Client Name: Ohio Department of Transportation
Job Title: Cleveland Innerbelt Design-Build Contract
Job Number: CUY-90-14.90
Document Title: Bulkhead Wall - RFI 87 Response

West Bank Wall - DM Elev. Raise

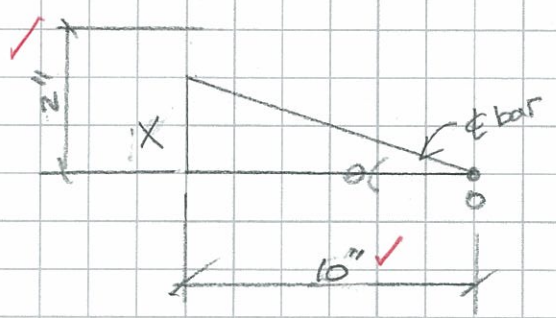
Contractor has requested to raise the elevation of the deadman anchorage west of Pier 4 to minimize excavation.

Determine the maximum increase in the anchorage elevation based on the geometry of the water anchorage.

$$z = 65 \tan 4 = 5.1$$

Say 5.0'

The dead man anchorage may be raised a maximum of 5'. The 4" phi conduit should be set at an inclination of approx 4'.

$$X = 2'' - 0.25'' (\text{CLR}) - 1/2(2'') = 0.75$$

$$\theta = \tan^{-1} (0.75/10) \approx 4^\circ$$
